Electronic Theatre Controls, Inc.
3030 Laura Lane
Middleton, WI 53562

Manual 4052M1019 Obsession Upgrade Installation Instructions

Obsession Full Console Upgrade Kit (4052S1018)

Figure 1

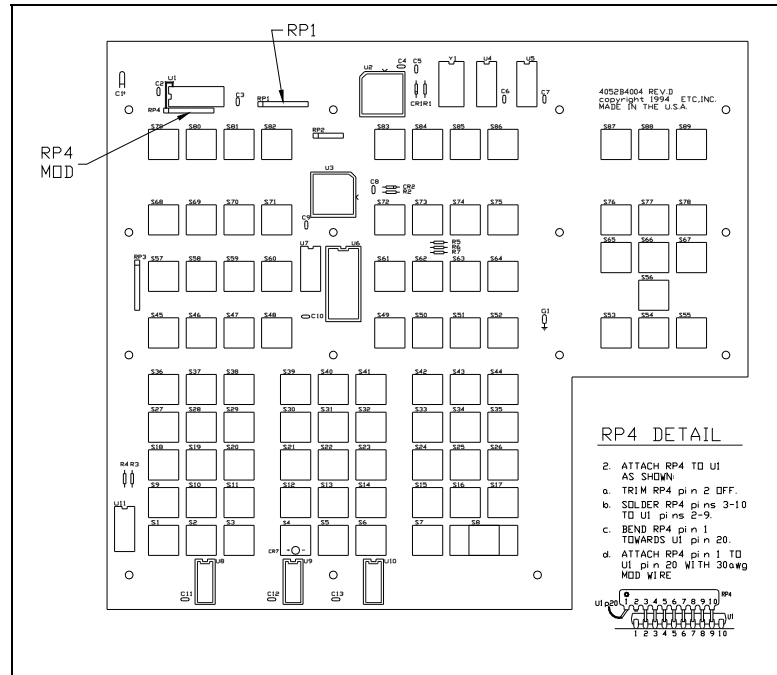
This modification adds resistor pull-ups to the BD data lines and changes another pull-up package to increase the current through the GO and STOP/BACK switches. When the FIFO empty flag is read through the local port, only bit zero is active and the rest of the bits float. This injects noise into the active bit and can cause it to be misread. The resistor pull-up for the GO and STOP/BACK switches is changed to a lower value to ensure sufficient current through the contacts.

1. Turn power OFF to the console and wait until it has cycled down.
2. Unplug the power cord from the power entry module.
3. Remove the LIVE, BLIND, GROUP, and SUB keycaps from the face panel button board.
4. Open the console for service.
5. Unplug all cables and harnesses from the face panel button board.
6. Remove the mounting screws and remove the board from the console.
7. Modify the board on the component side as follows¹:
 - a. Cut pin 2 off of the 4.7K resistor pack (part R316).
 - b. Prepare the resistor pack for installation by soldering a short piece of W106 wire onto the resistor pack pin 1.
 - c. Stand the resistor pack beside U1 with pin 10 of the resistor pack at pin 9 of U1. The pin 1 end of the resistor pack should project past the end of U1.

- d. Solder the pins of the resistor pack to the legs of U1 at pins 2 through 9.
 - e. Solder the short piece of W106 wire from pin 1 of the resistor pack to U1 pin 20.
 - f. Remove the resistor pack RP1 and replace with the 2.2K resistor pack (part R262)².
8. Reinstall the face panel button board.
 9. Reconnect all cables and harnesses which were previously removed.
 10. Reinstall the LIVE, BLIND, GROUP, and SUB keycaps on the face panel button board.
 11. Enter today's date on one of the ECO labels (part I204) and affix it to the PC board.

Figure 2

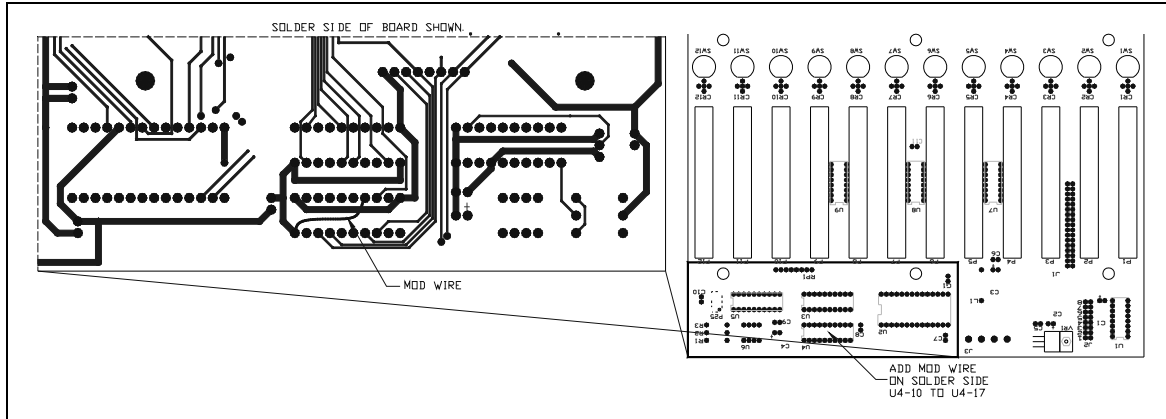
This modification grounds a floating bus buffer input. The face panel FIFO empty flag is read on this port along with the submaster bump buttons. The floating input injects enough noise into adjacent data lines to cause the flag and/or bump buttons to be misread. This procedure is performed on the boards without removing them from the console.

Note: Refer to Figure 2 during the following procedure when modifying 4052B5005 boards. These boards are identified by round bump buttons and one LED above each keycap. The board is shown inverted as it will appear when the console is opened for service.

Figure 3

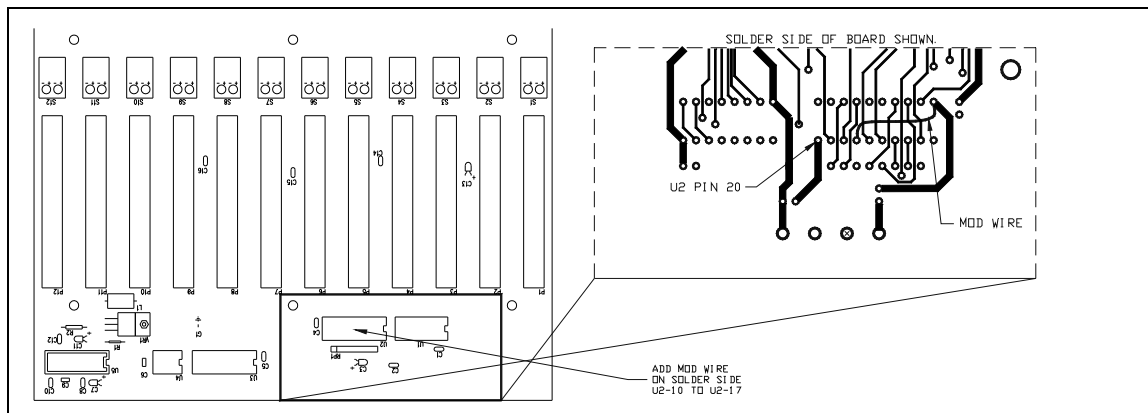
Note: Refer to Figure 3 during the following procedure when modifying 4052B5027 boards. These boards are identified by square bump buttons and two LED's in the keycap. The board is shown inverted as it will appear when the console is opened for service.

1. Ensure power is OFF to the console.
2. Connect U2 pin 17 to U2 pin 10 with W106 wire on the solder side of the board⁴.
3. Perform the previous steps on the second submaster board if one is installed.
4. Enter today's date on one of the ECO labels (part I204) and affix it to the PC board.

Figure 4

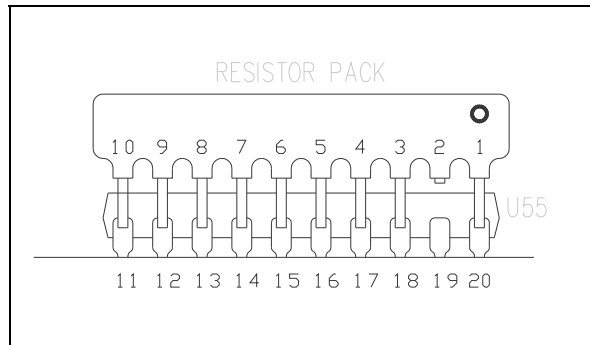
- l. Remove U44 and install a 74HC259 (part Z190)¹⁰.
 - m. Locate C30 and C31 close to the thin-net BNC and remove them from the board¹¹. Refer to Figure 4 while installing the resistor pack to U55¹².

- l. Remove U78 and install a 74HC259 (part Z190)¹⁸.
 - m. Locate C76 and C77 close to the thin-net BNC and remove them from the board. Refer to Figure 4 while installing the resistor pack to U55.

Figure 5

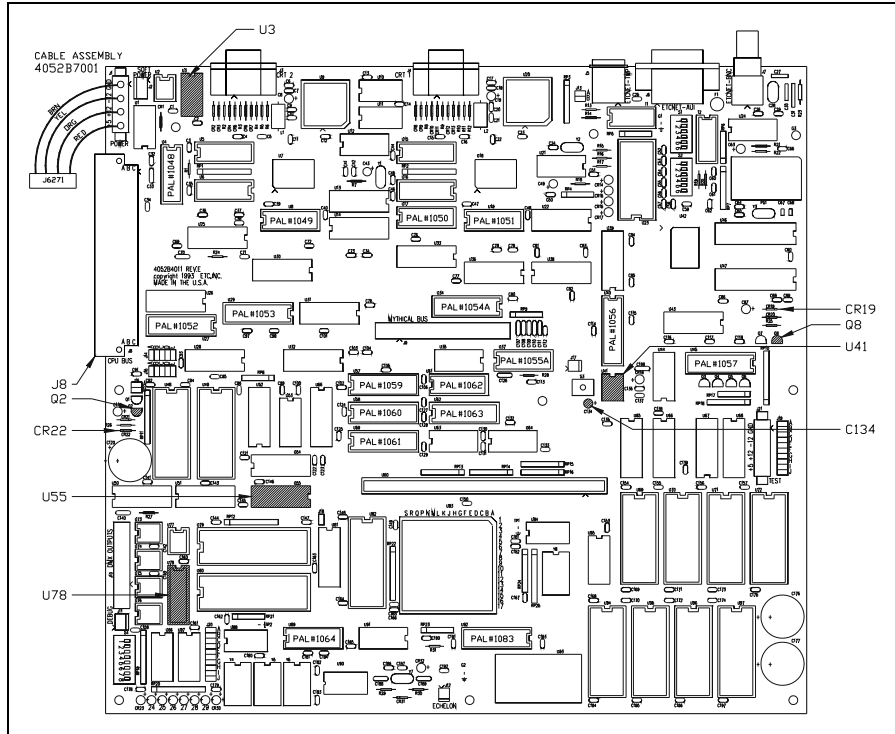
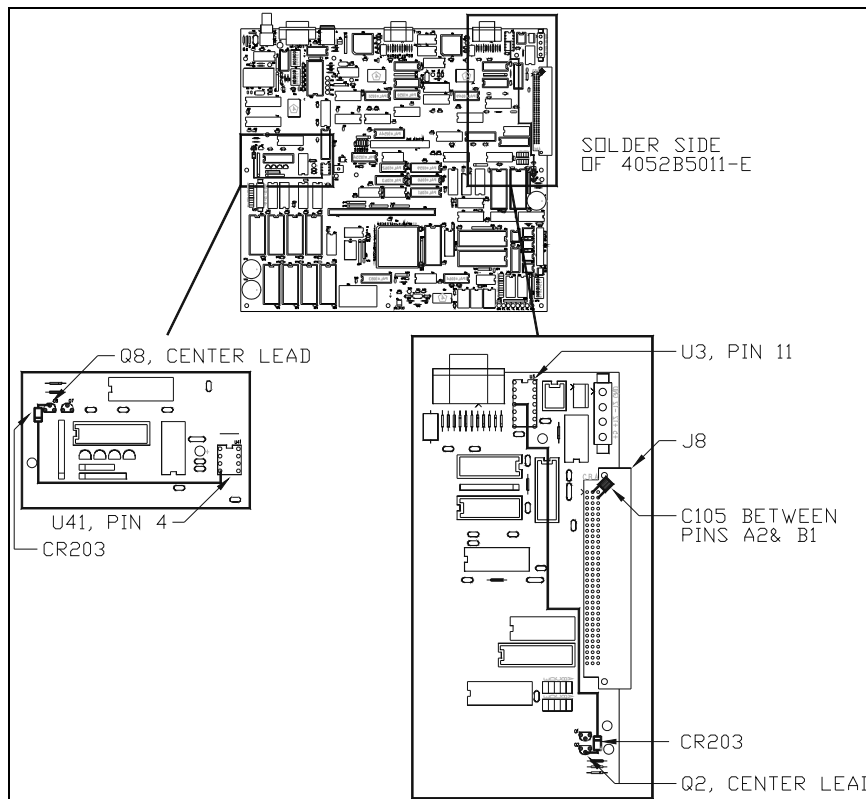
Note: Refer to Figure 5 and Figure 6 during modifications to the revision D and later Serf boards.

5. Remove the mounting screws and standoffs for the Serf board and remove the board from the chassis.
6. Modify the board as follows:
 - a. If U27 1052A is present, remove it and install U27 1052⁷.

- b. Remove U40 1056 and install U40 1056A⁸.
 - c. If there is a 30 AWG mod wire running from U27 pin 3 to either J8 pin A2 or U3 pin 12 on the solder side of the board, remove it.

- j. Remove CR19 and CR22 and replace them with 1N5229B zener diodes (part CR116).
 - k. Remove C134 and replace it with a 10 μ F/20 volt tantalum capacitor (part C168).

Figure 7

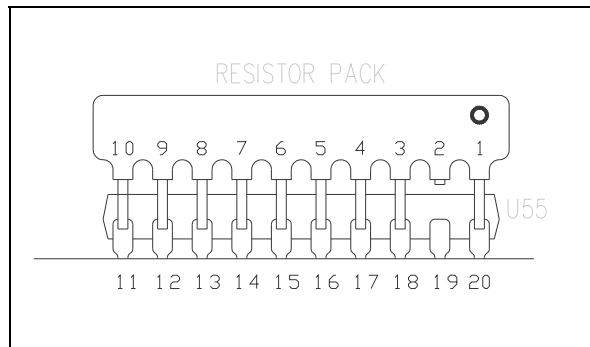
11. Install a resistor pull-up pack to U58 as follows⁶:
 - a. Refer to Figure 7 during the following procedure.
 - b. Cut pin 2 off of the 4.7K resistor pack (part R316).
 - c. Stand the resistor pack beside U58 with pin 1 of the resistor pack at pin 20 of U58.
 - d. Solder the pins of the resistor pack to the legs of U58 at pins 11 through 18 and pin 20.
12. Replace the Node board into the chassis and reinstall the mounting screws and standoffs to hold it in place.
13. Replace the external mounting hardware for the Node board connectors.
14. Reconnect all cables and harnesses which were previously removed.
15. Enter today's date on one of the ECO labels (part I204) and affix it to the PC board.

Figure 8

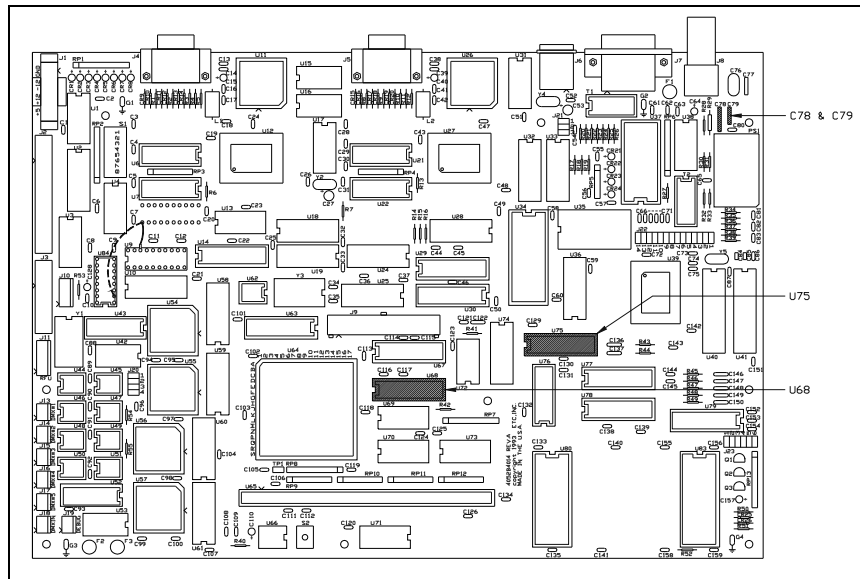
This modification changes PALs on the Node board and makes other changes which increase the reliability of the board.

Note: Refer to Figure 8 during the following procedure.

6. Thoroughly clean the inside of the chassis in the area of the Serf board to remove all metal filings and debris.
7. Remove U75 1025A and install U75 1025B².

8. Locate C78 and C79 close to the thin-net BNC and remove them from the board³.
9. Locate U68 and lift the label to identify the manufacturer of the part.

- a. If U68 is not a TI part, replace it with U68 (part PAL1024) from the parts kit⁴.
 - b. Discard the old GAL.
10. Remove the EPROM from U34 (part Z254) and replace it with the Flash EEPROM (part Z537)⁵.

Figure 9

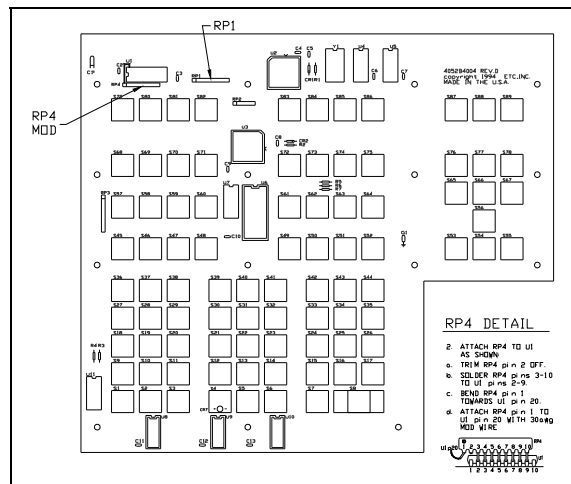
This modification adds resistor pull-ups to the BD data lines and changes another pull-up package to increase the current through the GO and STOP/BACK switches. When the FIFO empty flag is read through the local port, only bit zero is active and the rest of the bits float. This injects noise into the active bit and can cause it to be misread. The resistor pull-up for the GO and STOP/BACK switches is changed to a lower value to assure sufficient current through the contacts.

Note: Refer to Figure 9 during the following procedure.

- f. Remove the resistor pack RP1 and replace with the 2.2K resistor pack (part R262)⁸.
8. Reinstall the face panel button board.
9. Reconnect all cables and harnesses which were previously removed.

Figure 10

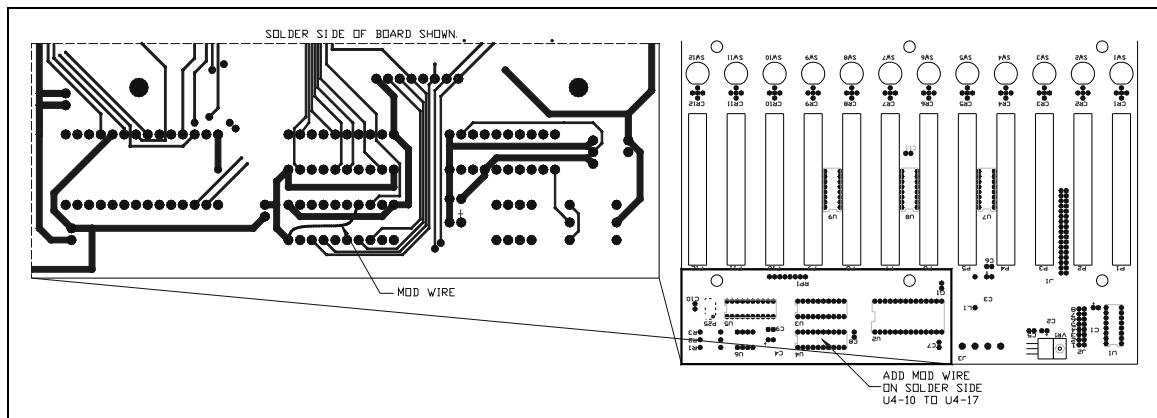
This modification grounds a floating bus buffer input. The face panel FIFO empty flag is read on this port along with the submaster bump buttons. The floating input injects enough noise into adjacent data lines to cause the flag and/or bump buttons to be misread. This procedure is performed on the boards without removing them from the console.

Note: Refer to Figure 10 during the following procedure when modifying 4052B5005 boards. These boards are identified by round bump buttons and one LED above each keycap. The board is shown inverted as it will appear when the console is opened for service.

1. Ensure power is OFF to the console.
2. Connect U4 pin 17 to U4 pin 10 with W106 wire on the solder side of the board⁹.
3. Perform the previous steps for the second submaster board if one is installed.
4. Enter today's date on one of the ECO labels (part I204) and affix it to the PC board.

Figure 11

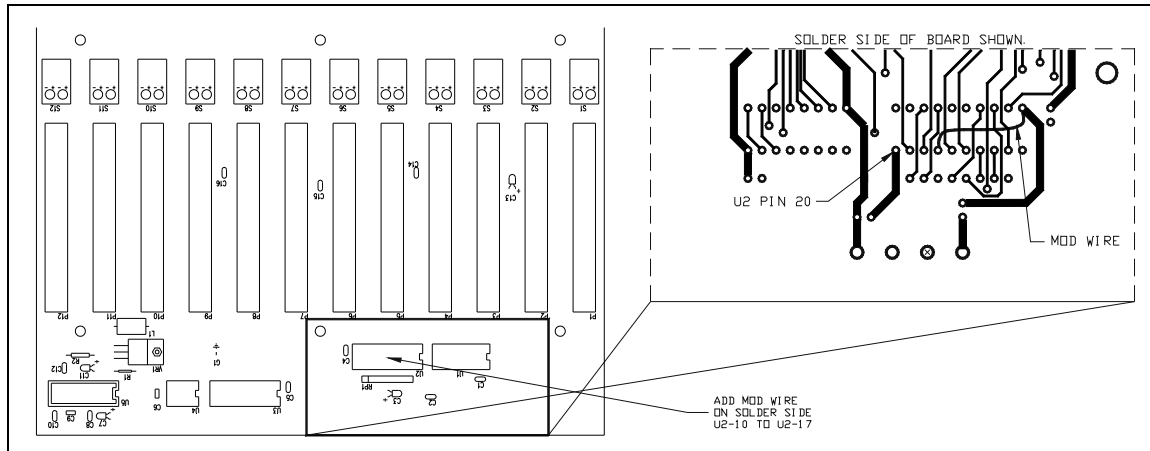
Note: Refer to Figure 11 during the following procedure when modifying 4052B5027 boards. These boards are identified by square bump buttons and two LEDs in the keycap. The board is shown inverted as it will appear when the console is opened for service.

Figure 12

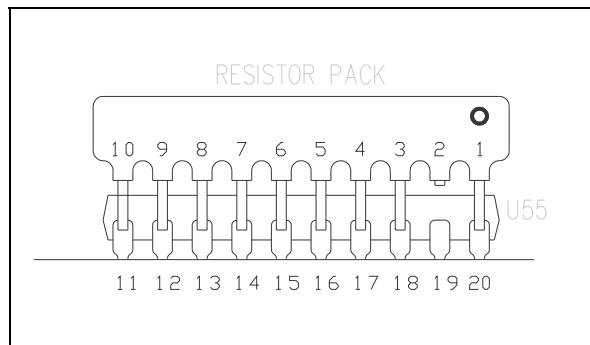
- l. Remove U44 and install a 74HC259 (part Z190)⁴.
 - m. Locate C30 and C31 close to the thin-net BNC and remove them from the board⁵. Refer to Figure 12 while installing the resistor pack to U55.

- l. Remove U78 and install a 74HC259 (part Z190)¹².
 - m. Locate C76 and C77 close to the thin-net BNC and remove them from the board¹³. Refer to Figure 12 while installing the resistor pack to U55¹⁴.

Figure 13

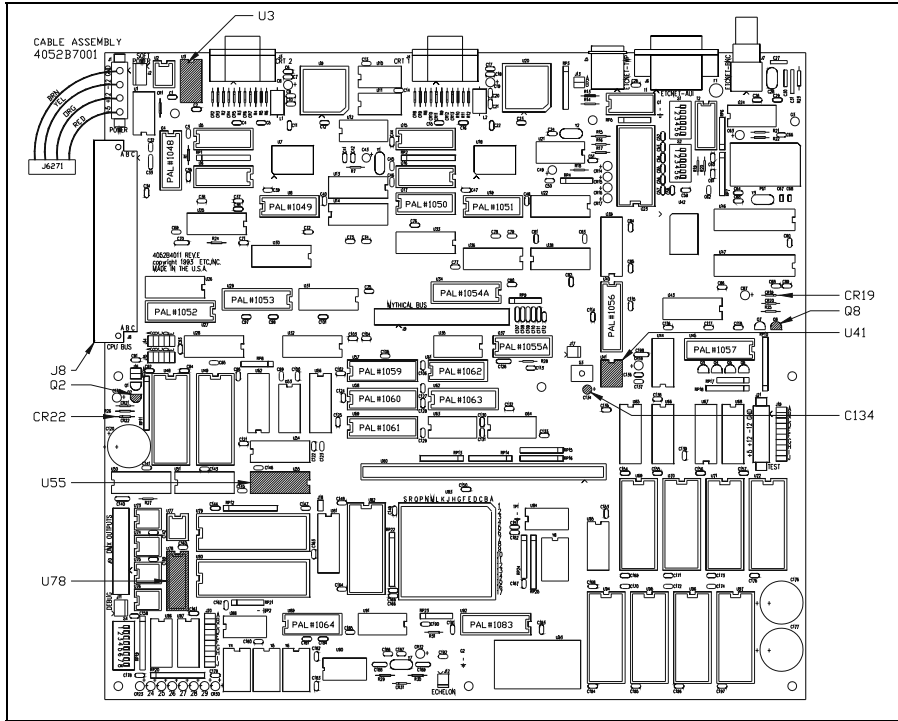
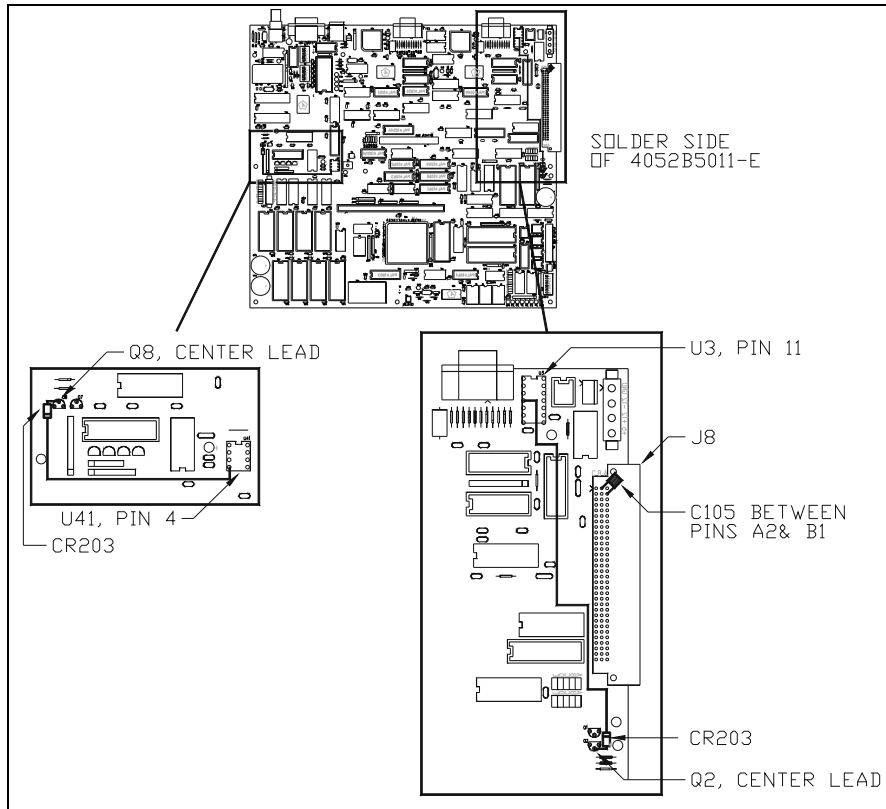
Note: Refer to Figure 13 and Figure 14 during modifications to the revision D and later Serf boards.

9. Modify the board as follows:
 - a. If U27 1052A is present, remove it and install U27 1052¹.
 - b. Remove U40 1056 and install U40 1056A².
 - c. If there is a 30 AWG mod wire running from U27 pin 3 to either J8 pin A2 or U3 pin 12 on the solder side of the board, remove it.

- j. Remove CR19 and CR22 and replace them with 1N5229B zener diodes (part CR116).
 - k. Remove C134 and replace it with a 10 μ F/20 volt tantalum capacitor (part C168).

Figure 15

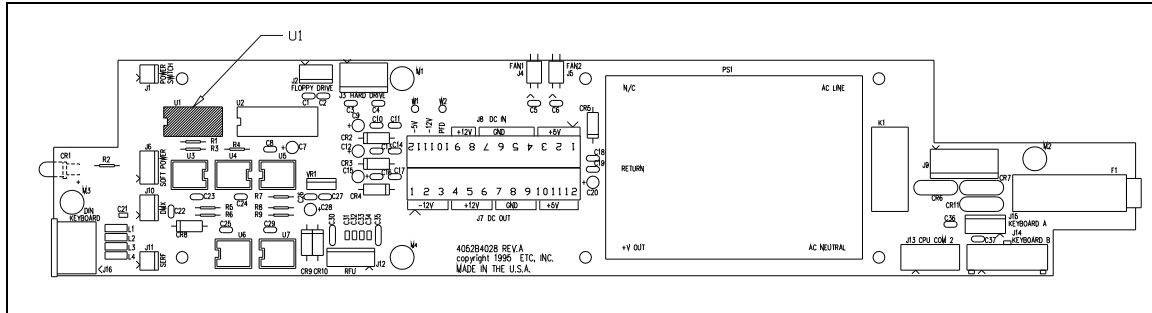
Refer to Figure 15 during the following procedure.

1. Ensure power is OFF to the RPU.
2. Disconnect all cables and harnesses from the power distribution board.
3. Remove the mounting screws and remove the power distribution board.
4. Remove the 74LS259 at U1 and install the 74HC259 (part Z181)¹⁹.
5. Reinstall the power distribution board into the chassis.
6. Reconnect all cables and harnesses previously removed.
7. Enter today's date on one of the ECO labels (part I204) and affix it to the PC board.

Figure 16

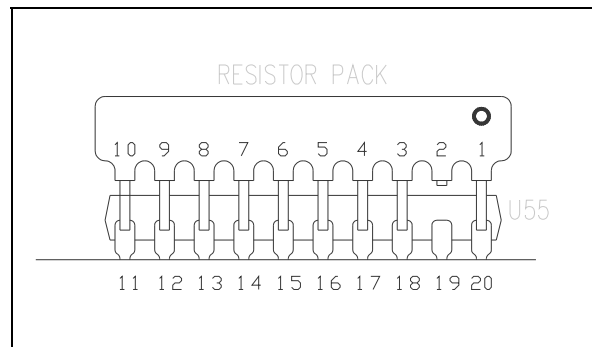
Refer to Figure 16 during the following procedure.

- b. Stand the resistor pack beside U58 with pin 1 of the resistor pack at pin 20 of U58.
 - c. Solder the pins of the resistor pack to the legs of U58 at pins 11 through 18 and pin 20.
14. Replace the Node board into the chassis and reinstall the mounting screws and standoffs to hold it in place.
 15. Replace the external mounting hardware for the Node board connectors.
 16. Reconnect all cables and harnesses which were previously removed.
 17. Enter today's date on one of the ECO labels (part I204) and affix it to the PC board.

Figure 17

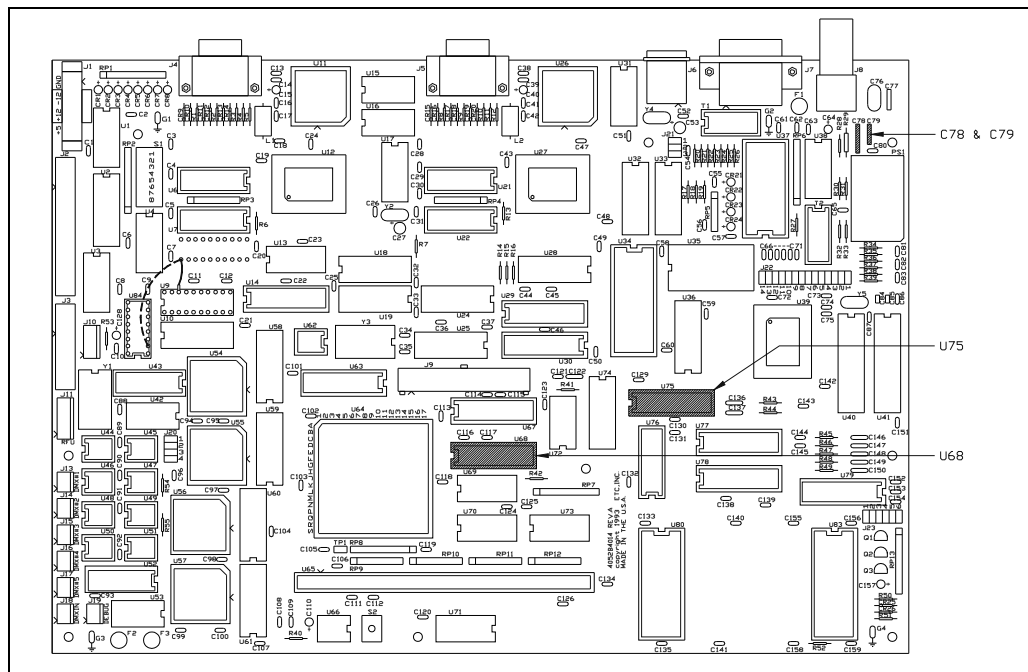
Note: This modification changes PALs on the Node board and makes other changes which increase the reliability of the board. Refer to Figure 17 during the following procedure.

8. Thoroughly clean the inside of the chassis in the area of the Node board to remove all metal filings and debris.
9. Remove U75 1025A and install U75 1025B².

10. Locate C78 and C79 close to the thin-net BNC and remove them from the board³.
11. Locate U68 and lift the label to identify the manufacturer of the part⁴.

- a. If U68 is not a TI part, replace it with U68 (part PAL1024) from the parts kit.
 - b. Discard the old GAL.
12. Remove the EPROM from U34 (part Z254) and replace it with the Flash EEPROM (part Z537)⁵.

Figure 18

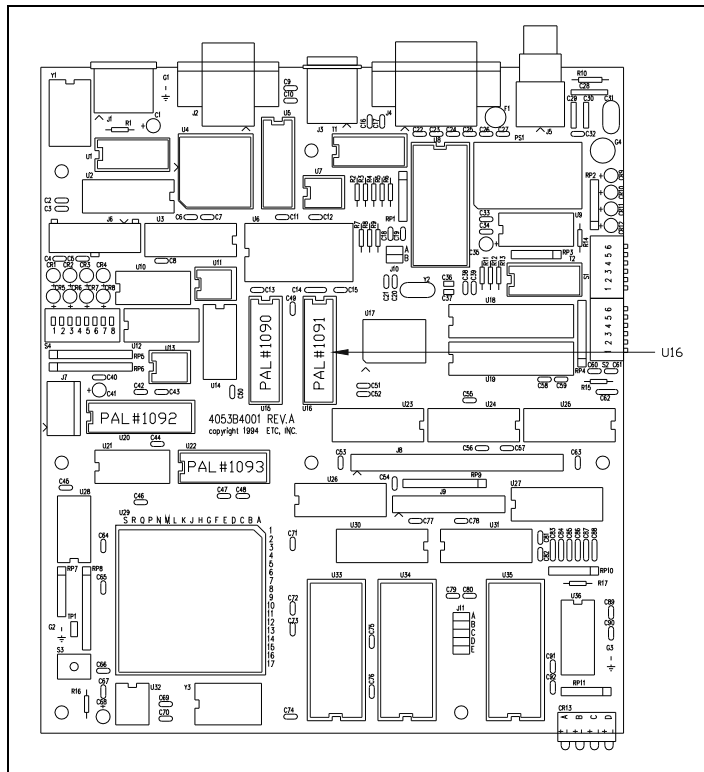
This modification changes a PAL on the RVI CPU board and makes other changes which increase the reliability of the board.

Note: Refer to Figure 18 during modifications to the RVI CPU board.
